P-7333

28977

**JINDAL ALUMINIUM LTD.**  
BANGALORE-560073 (INDIA)

PARTY'S NAME	GENERAL CATEGORY, DELHI MARKET
PARTY'S DRAWING No.	AS PER DRAWING
ALLOY & TEMPER	HE9 WP
DESCRIPTION	MISC. PROFILE

NAME	DATE
DRAWN	PRASANN.H	27-06-2007
CHECKED		
APPROVED		
SCALE		2:1
AREA mm <sup>2</sup>		397.826
PERIMETER mm.		209.885
WEIGHT kg/m		1.074 ②
DRAWING No.	SECTION No.	
P-7333	-	
28977	28977-ISSUE-2

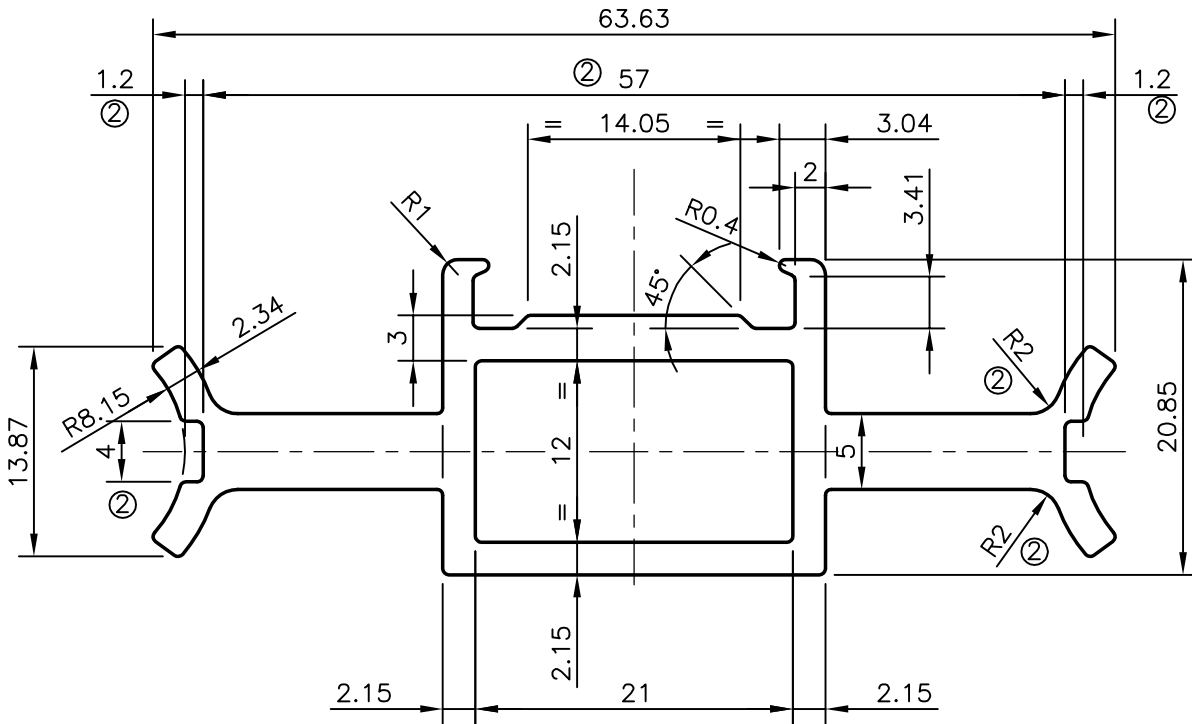
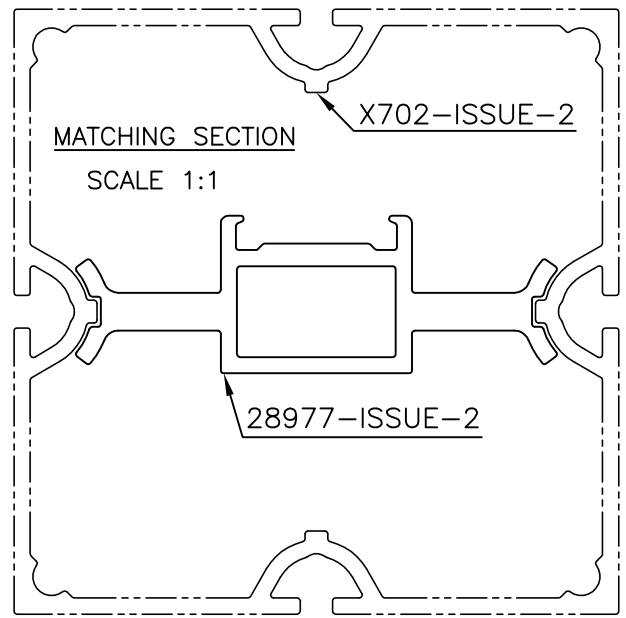
ISSUE- ② DIMENSION CHANGED FROM 3.20 mm TO 4.00 mm, 1.18 mm TO 1.20 mm, 57.68 mm TO 57.00 mm, RADIUS CHANGED FROM R0.4 mm TO R2.0 mm AND WEIGHT ALSO CHANGED FROM 1.079 kg/M TO 1.074 kg/M & THIS SECTION MATCH WITH SECTION NO-X702-ISSUE-2
